Onondaga County Planning Board

MEETING AGENDA

Wednesday, August 5, 2026
11:00 AM

ONONDAGA COUNTY PLANNING BOARD STAFF REPORT AUGUST 05 2026 S-26-24

Z-26-179, Z-26-180

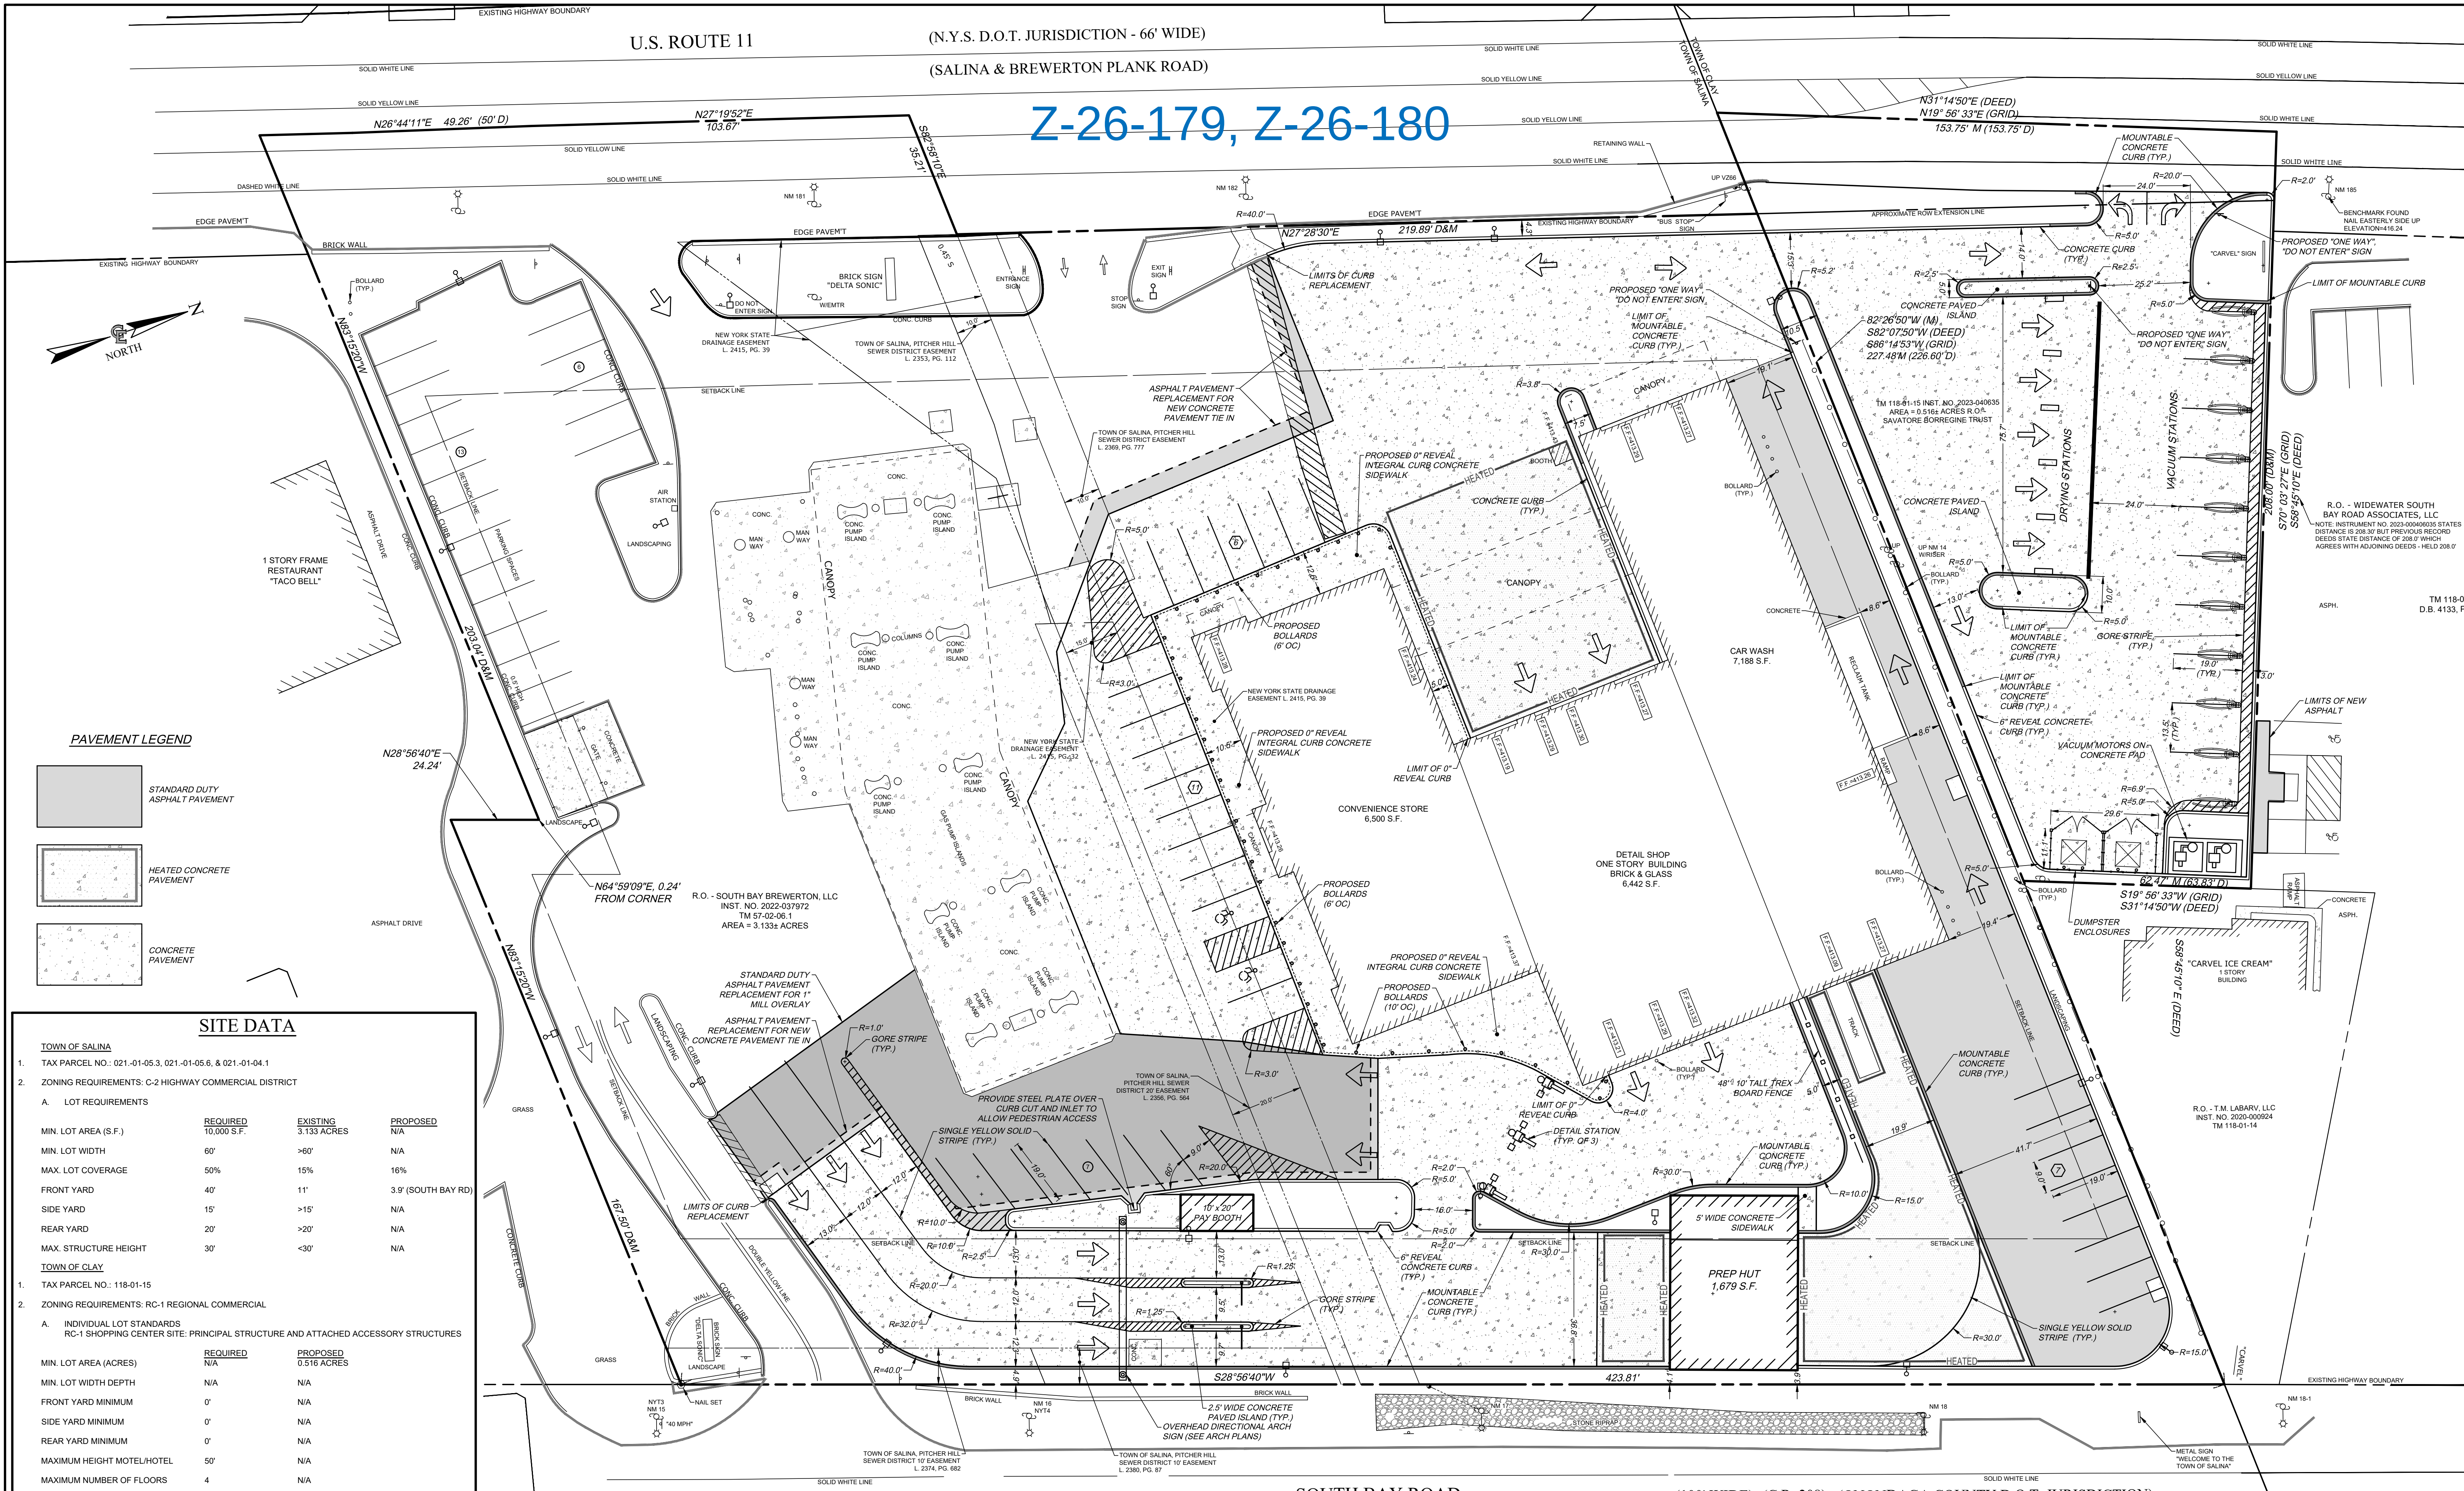
Past Board Reviews:	Special Permit referral (Z-26-158) from the Town of Clay regarding this proposed Delta Sonic expansion into the adjacent parcel. The Board advised the applicant to coordinate with NYS Department of Transportation (NYSDOT) regarding Brewerton Road access and due to the site being located in a County drainage district, to submit a Stormwater Pollution Prevention Plan (SWPPP) or drainage plan to the Onondaga County Department of Water Environment Protection (WEP). The Board also encouraged the applicant and Town to consider installation of sidewalks along both Brewerton Road and South Bay Road frontages.
Concurrent Reviews:	Area variance referral (Z-26-180) to allow the proposed renovations.
Location:	The site is located in a commercialized area between Brewerton Road and South Bay Road. The existing Delta Sonic facility is located within the Town of Salina, abutting the municipal boundary with the Town of Clay. The proposed site changes include expanding into the adjacent Town of Clay parcel to the north.

(cont'd):	The existing Delta Sonic facility contains a car detailing building, fueling station, and convenience store. The drive-thru for the car wash/detailing building circulates along the South Bay Road frontage before entering the building situated along the northern boundary of the Town of Salina parcel. Town of Clay parcel: This parcel currently contains a portion of a small commercial plaza, to be demolished, to allow renovation and expansion of the Delta Sonic facility to the south.
Project Detail:	Per the Site and Pavement Marking Plan dated 4/15/26, the existing Delta Sonic facility will be renovated to incorporate the Town of Clay parcel. Town of Salina site renovations will include installing new concrete in the drive-thru lanes, installing a 1,679 sf Prep Hut in front of the Detail Shop and a concrete parking area in front of the main entrance. An asphalt parking area will be installed adjacent to the drive-thru lanes and an asphalt driving lane and parking area will be re-installed along the northern parcel boundary. Town of Clay site renovations include installing concrete across the site along with installation of vacuum stations along the northern parcel boundary, a drying station area at the center of the parcel, and a new dumpster enclosure and vacuum motor area along the eastern site boundary. New concrete will be installed to connect the two parcels along the Brewerton Road frontage, across the municipal boundary.

Landscaping: Per the Landscape Plan dated 4/15/26, topsoil, shrubs, trees, and landscaping will be installed along the Town of Clay's Brewerton Road frontage, along the municipal boundary and at the rear boundaries of both parcels, and around the drive-thru lanes. Trees will also be installed along the southern boundary of the Town of Salina parcel.

ADVISORY NOTE: The Onondaga County Department of Water Environment Protection (OCDWEP) may require capacity assurance due to a possible change in use. Additionally, unless it can be demonstrated that anticipated sanitary flows will not exceed previous flows in excess of one sewer unit over prior uses, the applicant must develop a 1 gallon to 1 gallon sanitary flow offset plan/project in coordination with the municipal engineer. The Capacity Assurance Form and approval process can now be found online: <http://ongov.net/wep/connections.html>

WEST SITE PLAN

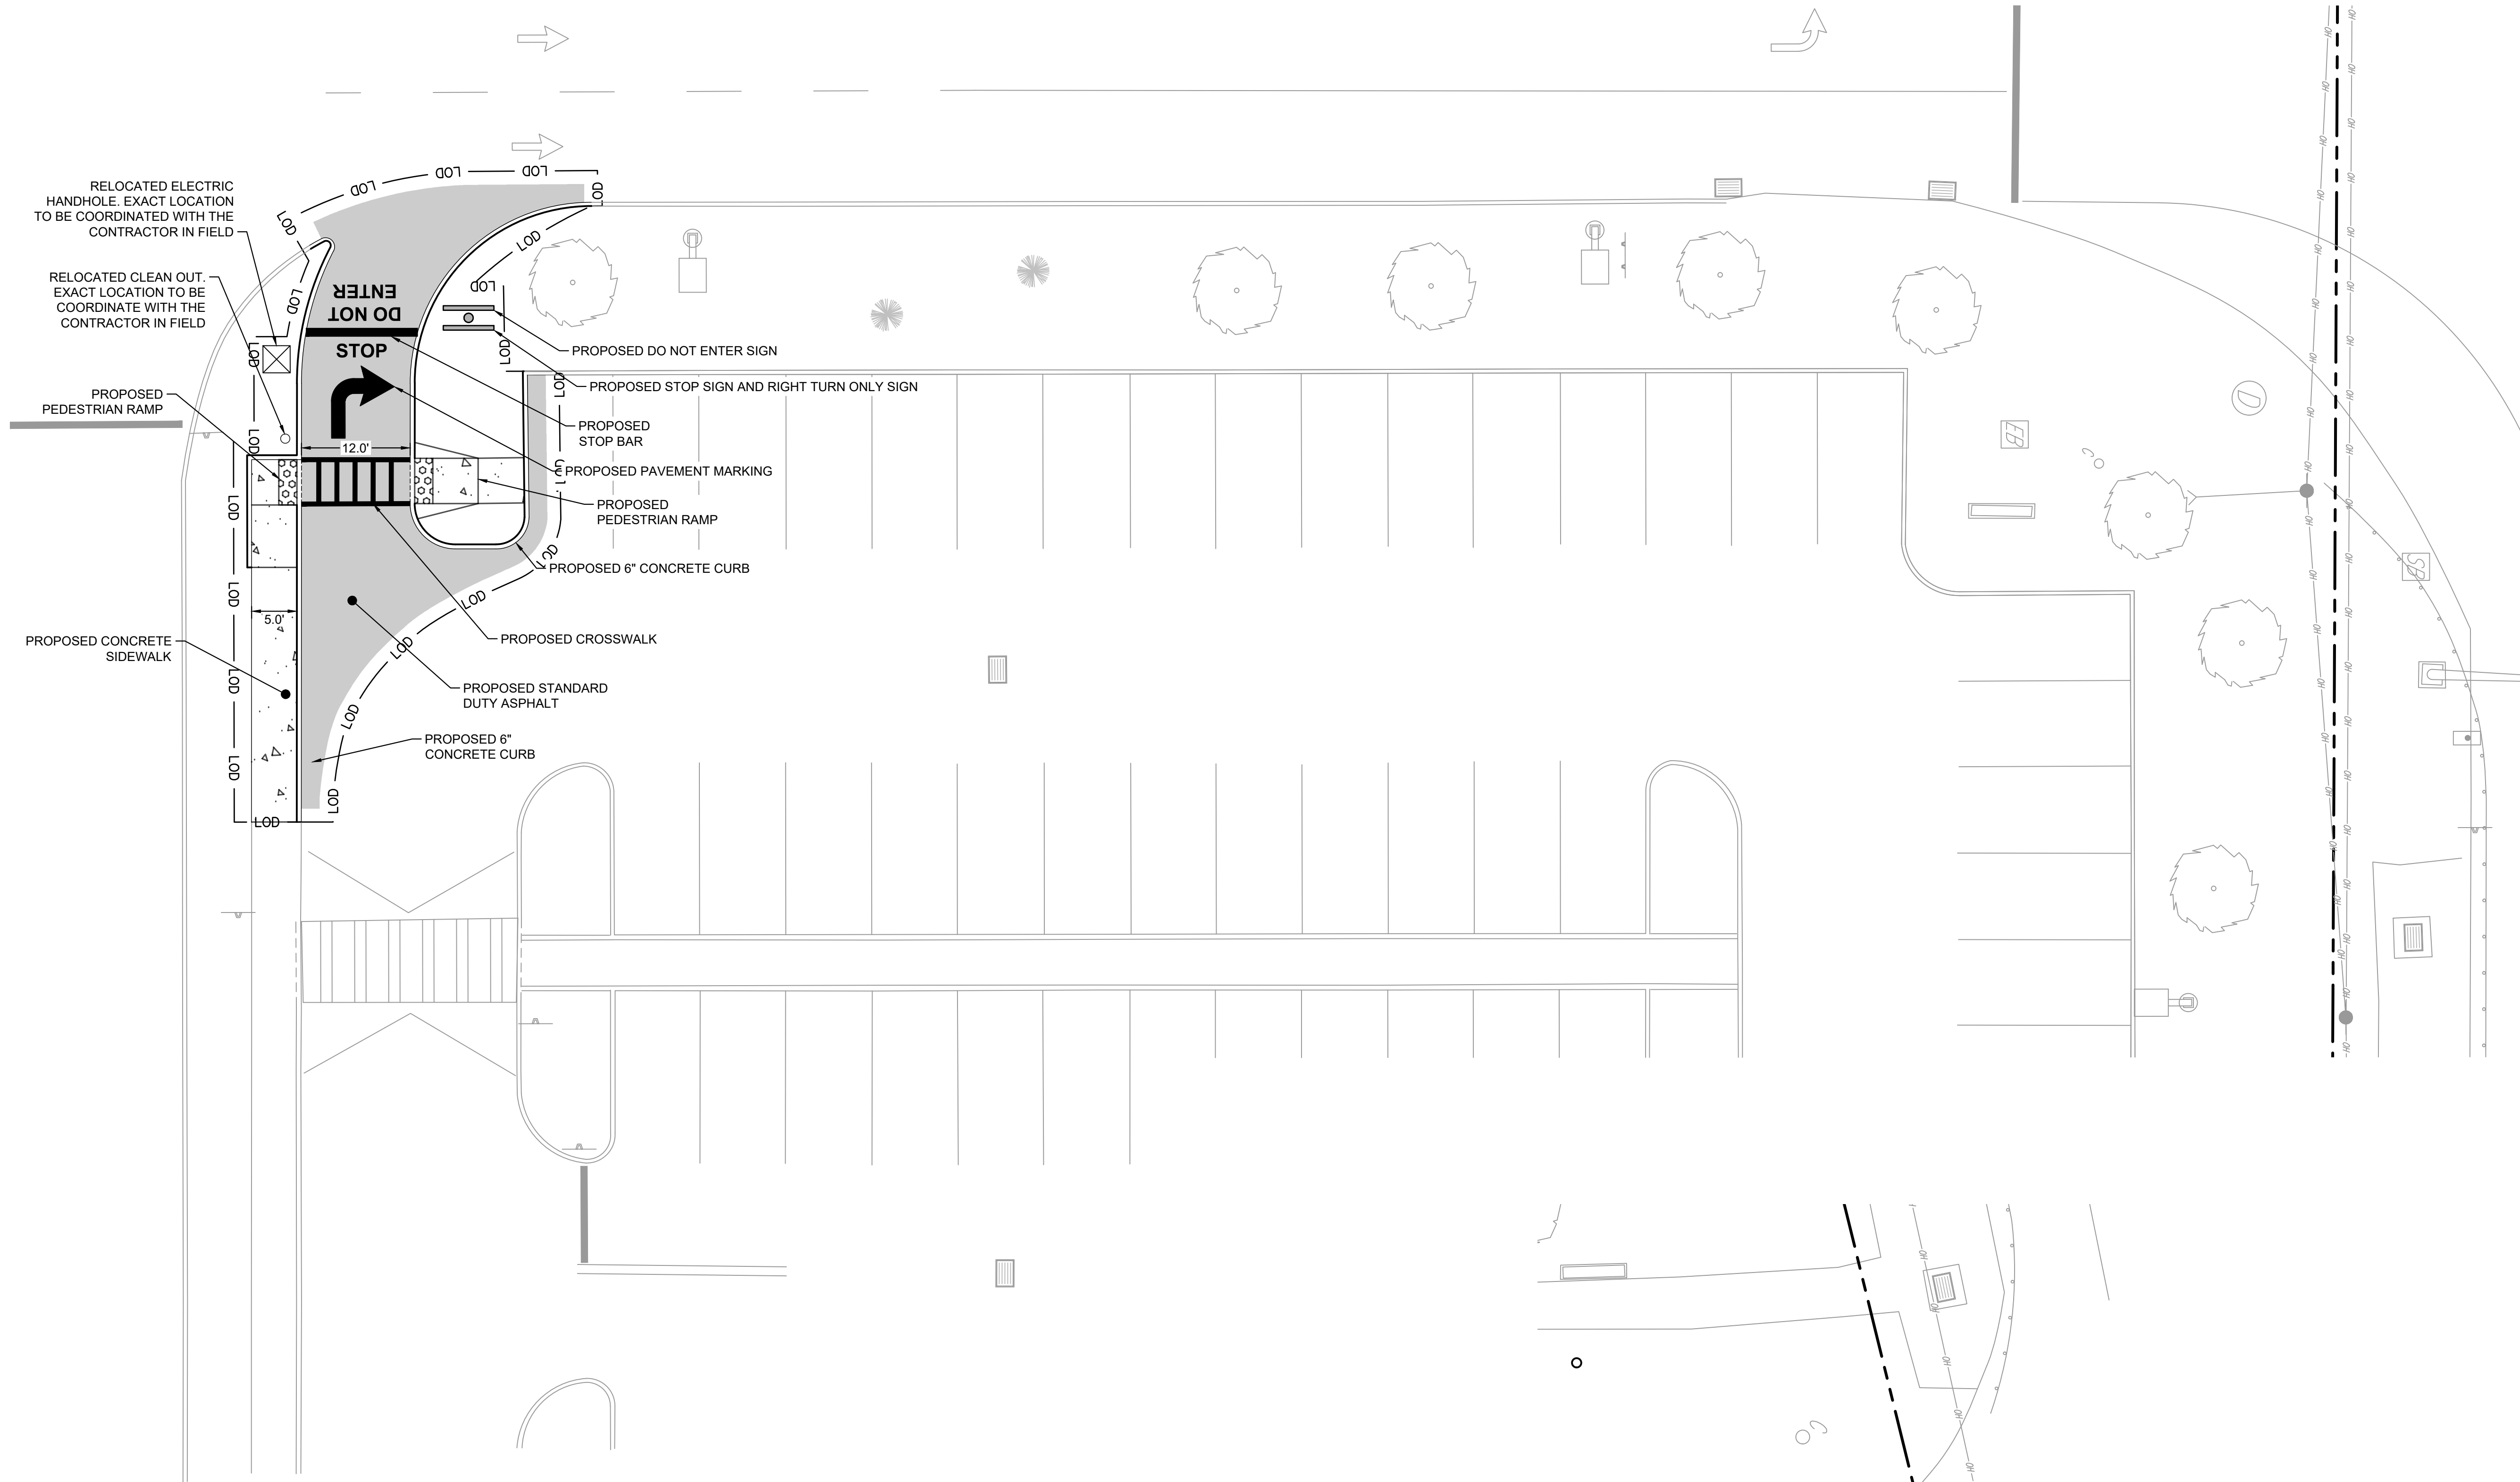
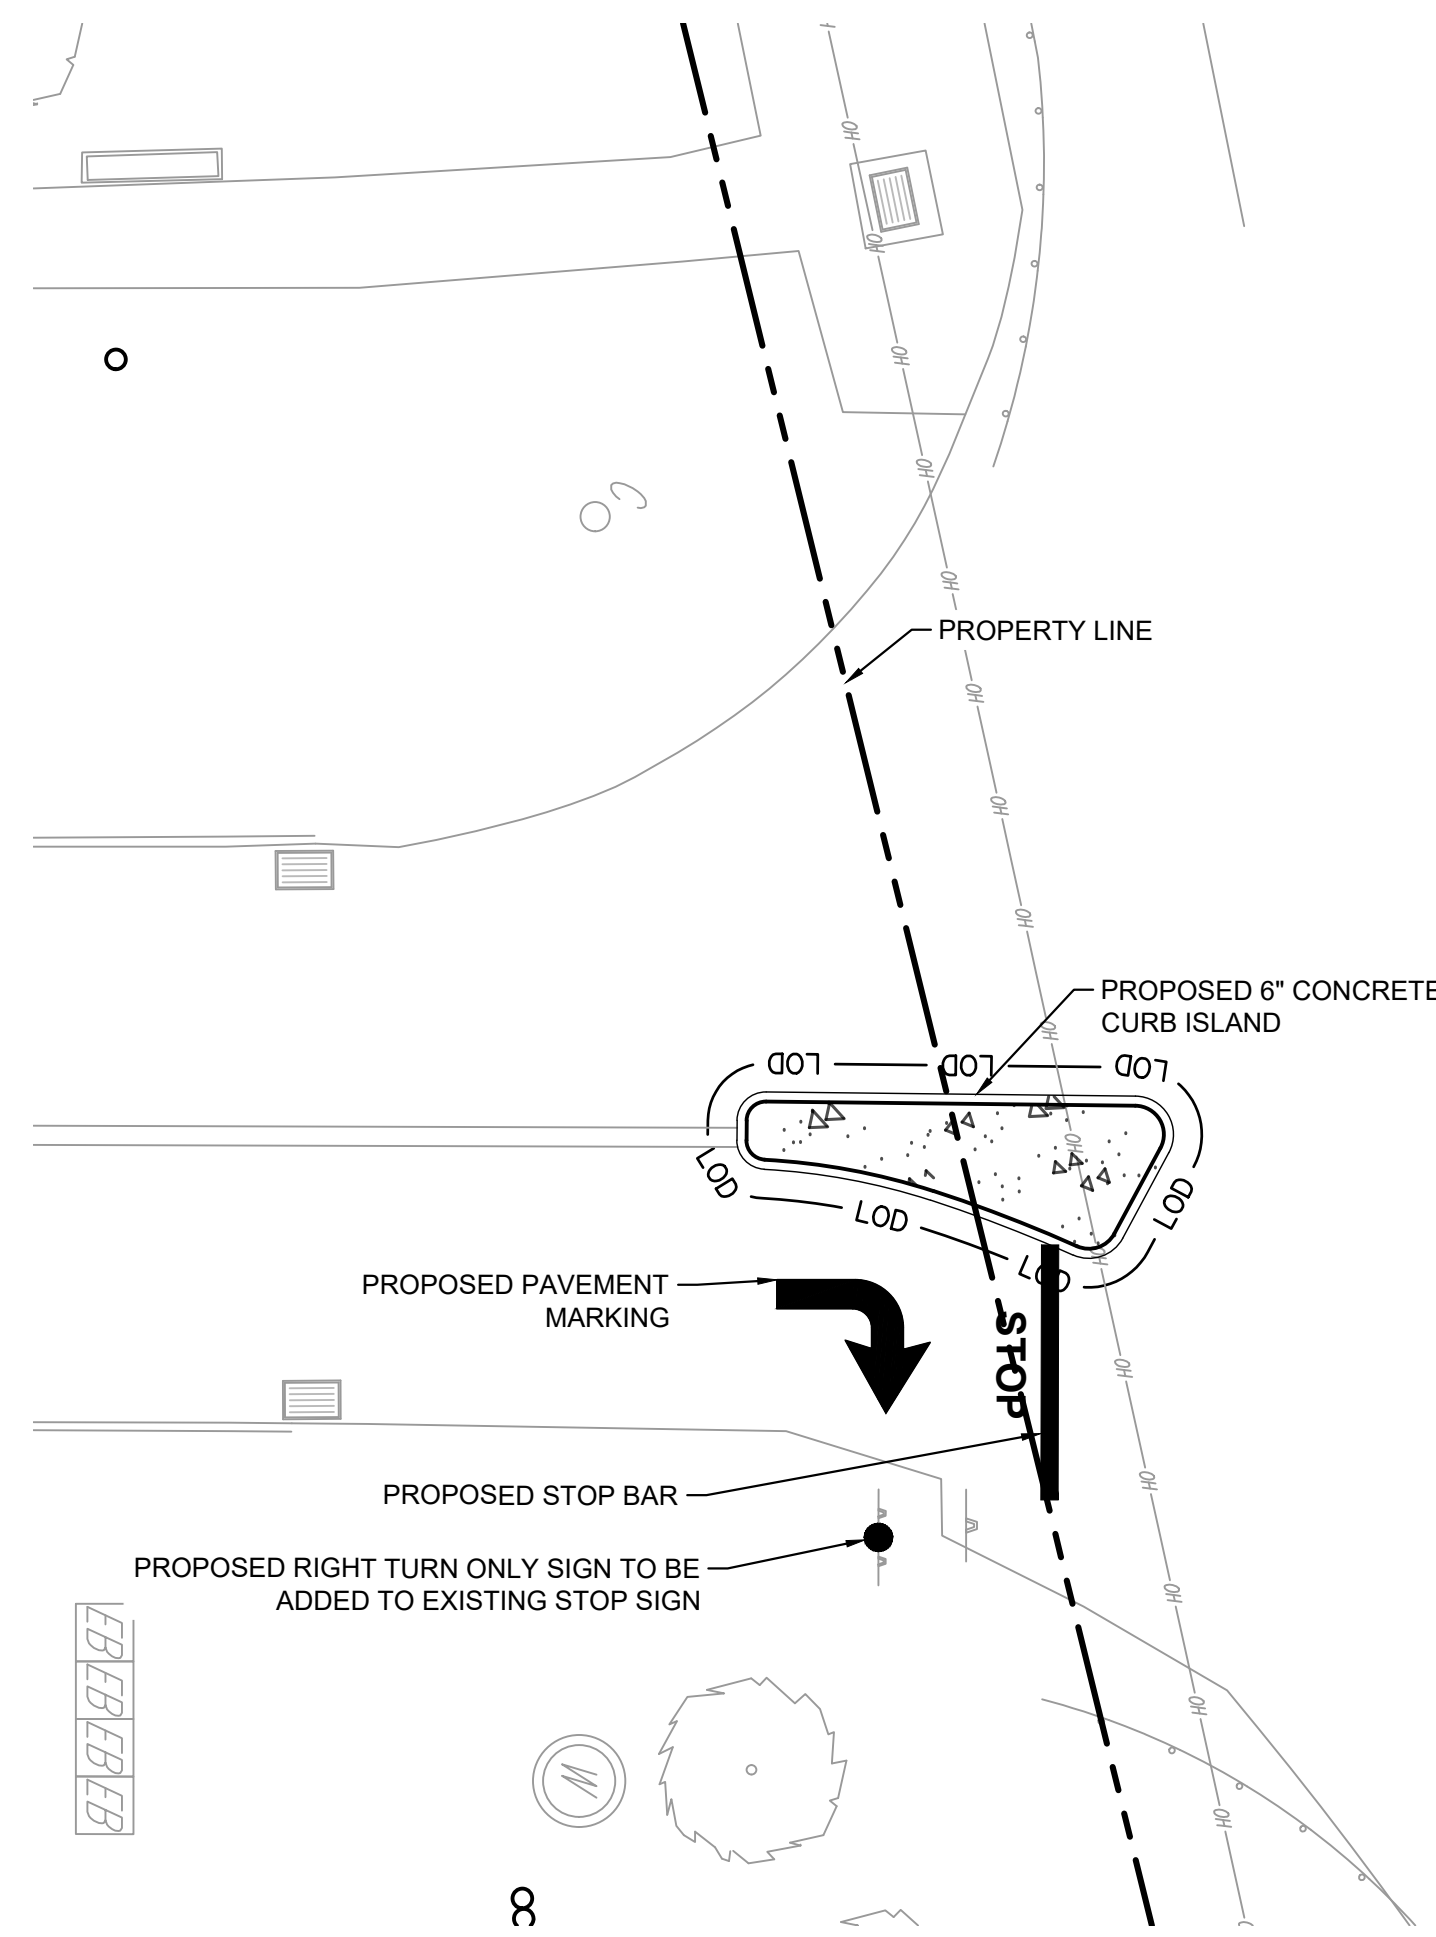
Wetlands: GIS mapping shows southern and eastern portions of the parking areas may contain state and federal wetlands, which appear to exclude the subject area. Wetland boundaries are not depicted in the plans and per GIS mapping do not appear to be located in the subject areas.

Plants/Animals: The site may contain the Indiana bat or Northern long-eared bat, or their associated habitats, which have been listed by the state or federal government as threatened or endangered animal species (per EAF Mapper). Impacts to bat species are often associated with tree clearing and from the plans it appears that no trees will be removed as part of the proposed project.
